CONSTRUCTION PLANS FOR SAND HILL LAKE DAM MODIFICATIONS 2019

SAND HILL RIVER WATERSHED DISTRICT POLK COUNTY MINNESOTA

H:\Fargo\1800\1812\1812_0063\CAD\Plans\Addendum No. 1\Plan and Profile\Addendum No. 1.dwg-3-10/28/2019 9:31 AM-(buhler)

ROCK ARCH
 PLAN AND PROFILE
 PROJECT NO. 1812-0063

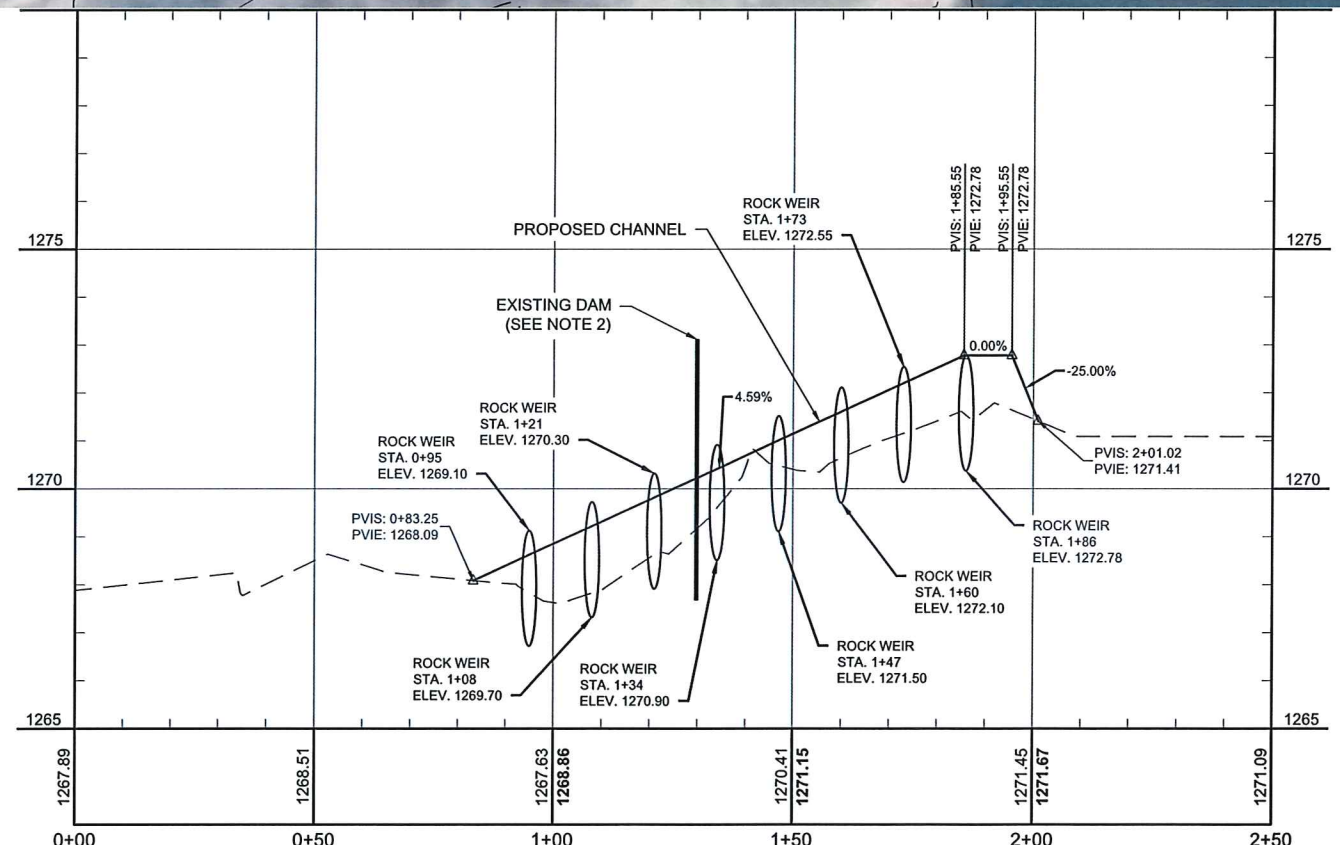
No.	Revision	Date	By
1	REVISED ROCK FISH PASSAGE SURFACE ELEVATIONS	10-28-2019	BAU

ROCK WEIR LAYOUT
NOT TO SCALE

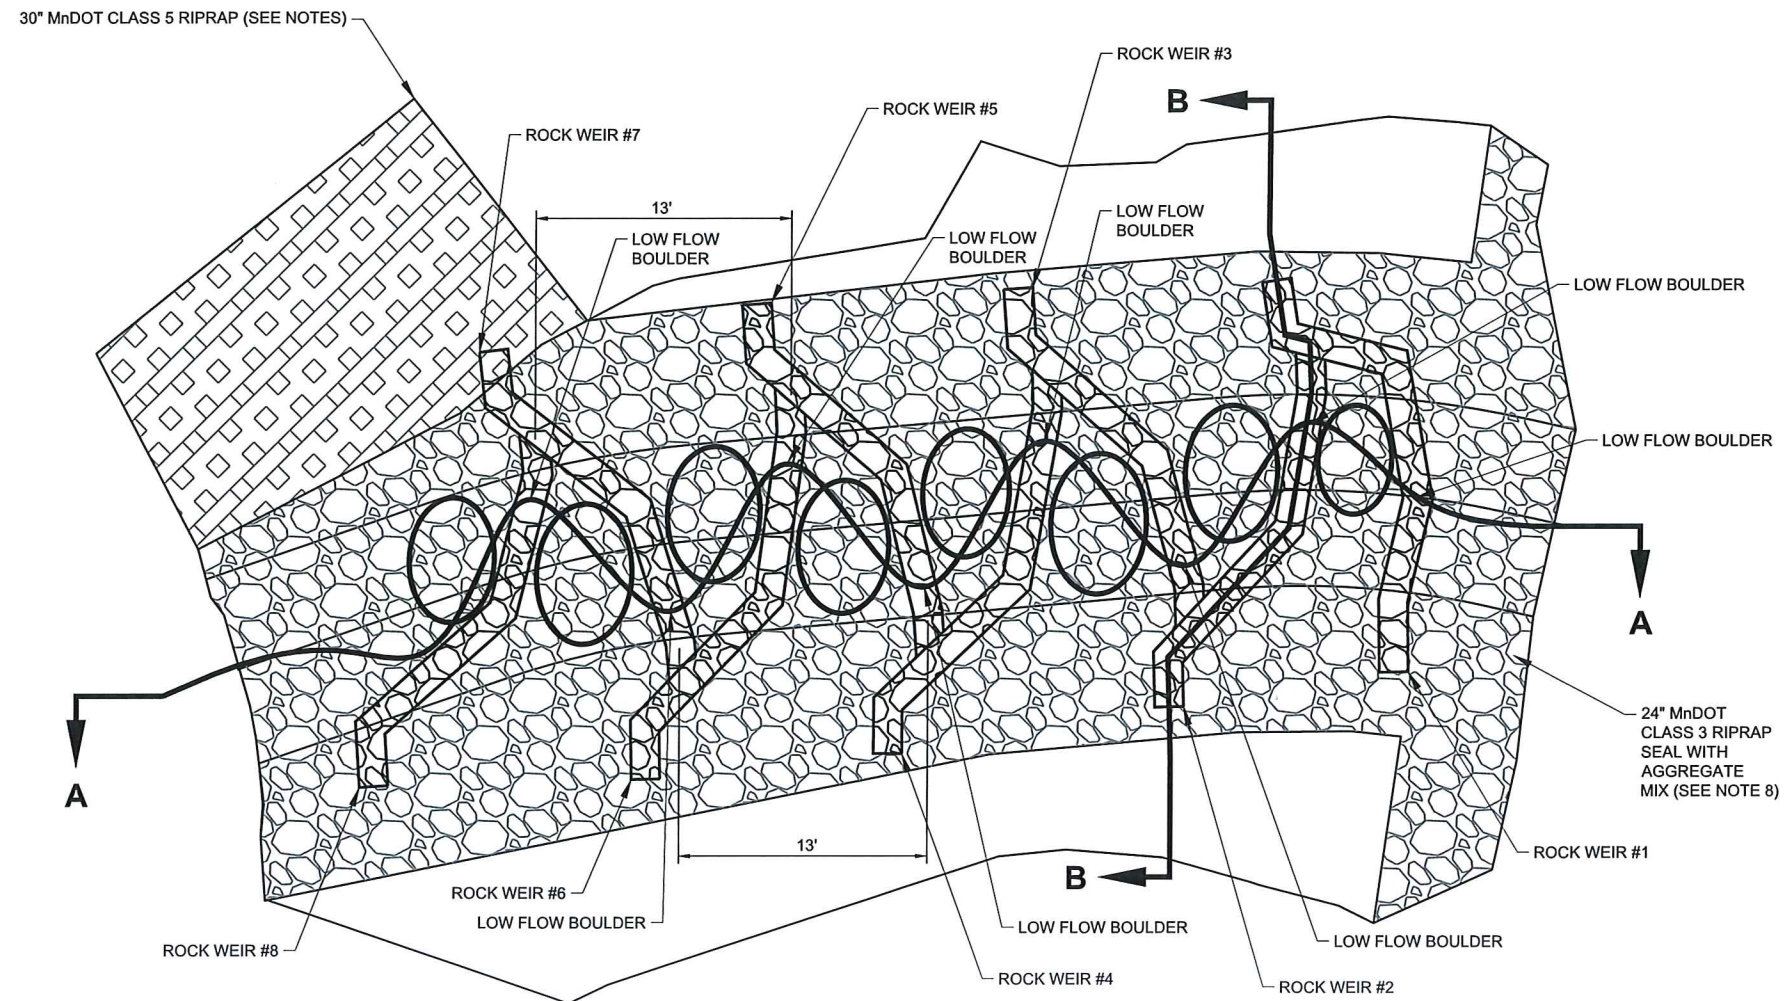
1		REVISED LOW FLOW BOULDER ELEVATIONS	10-28-2019	BAU	Erik S. Jones Erik S. Jones License No. 41161	10/28/2019			Fargo	Drawn by BAU	Date 10-28-19	SAND HILL LAKE DAM MODIFICATIONS SAND HILL RIVER WATERSHED DISTRICT FERTILE, MINNESOTA	ROCK WEIR LAYOUT PROJECT NO. 1812-0063	SHEET 4 of 5
No.	Revision	Date	By						Checked by ESJ	Scale AS SHOWN

ROCK WEIR	LOW FLOW BOULDER ELEVATION	HIGH BOULDER ELEVATION (SOUTH)	HIGH BOULDER ELEVATION (NORTH)
1	1272.78	1275.00	1275.00
2	1272.55	1274.50	1275.00
3	1272.10	1274.50	1274.75
4	1271.50	1273.70	1274.75
5	1270.90	1273.70	1273.20
6	1270.30	1272.30	1273.20
7	1269.70	1272.30	1271.60
8	1269.10	1271.30	1271.60

ROCK WEIR DETAIL
NOT TO SCALE

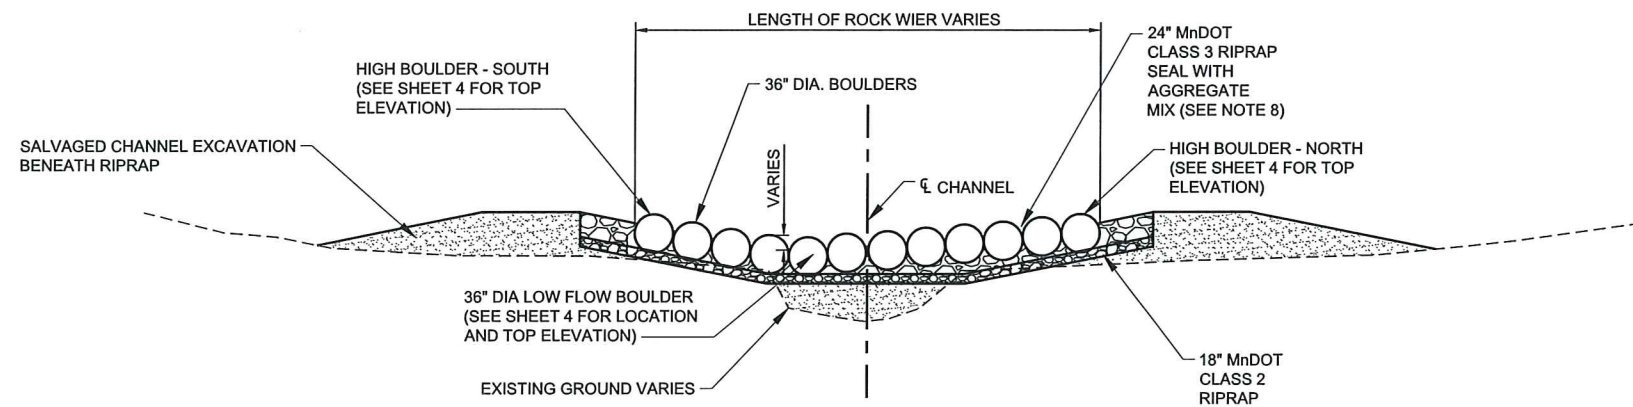
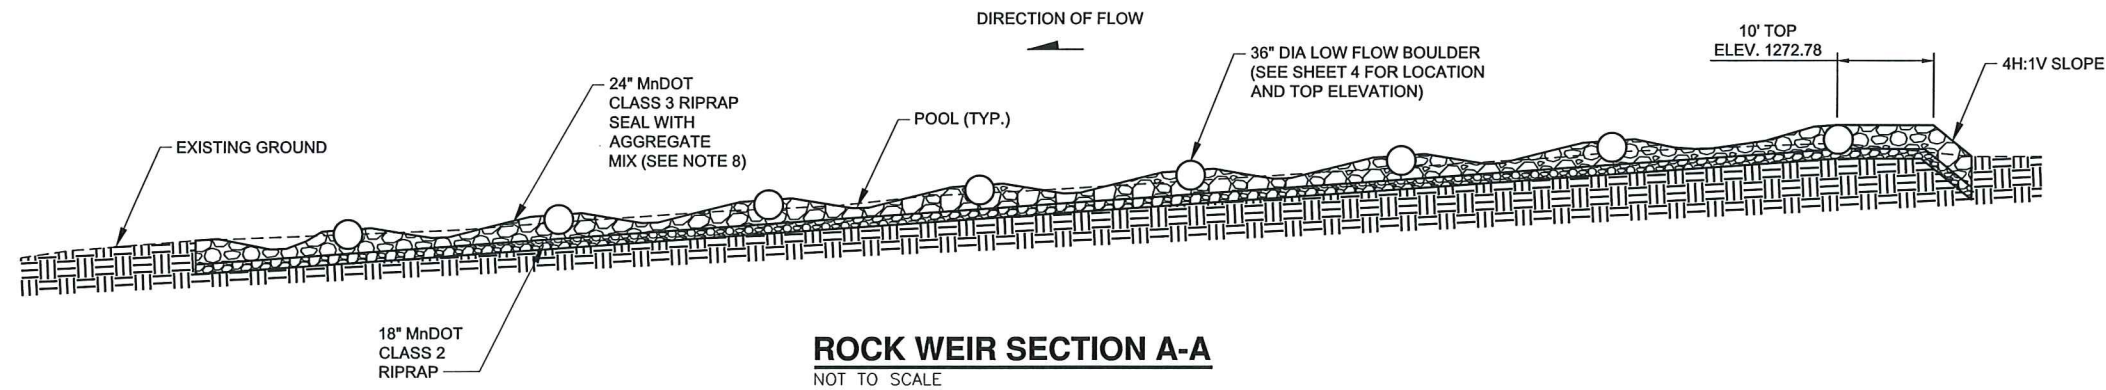
1		REVISED ROCK WEIR SECTION A-A DETAIL	10-28-2019	BAU	I hereby certify that this plan, specification, or report was prepared by me or under my direct supervision, and that I am a duly Licensed Professional Engineer under the laws of the State of Minnesota. <i>Erik S. Jones</i> Erik S. Jones License No. 41161				Fargo	Drawn by BAU	Date 10-28-19	SAND HILL LAKE DAM MODIFICATIONS SAND HILL RIVER WATERSHED DISTRICT FERTILE, MINNESOTA	ROCK WEIR DETAILS PROJECT NO. 1812-0063	SHEET 5 of 5
No.	Revision	Date	By	Date	P: 701.237.5065 F: 701.237.5101	Checked by ESJ	Scale AS SHOWN
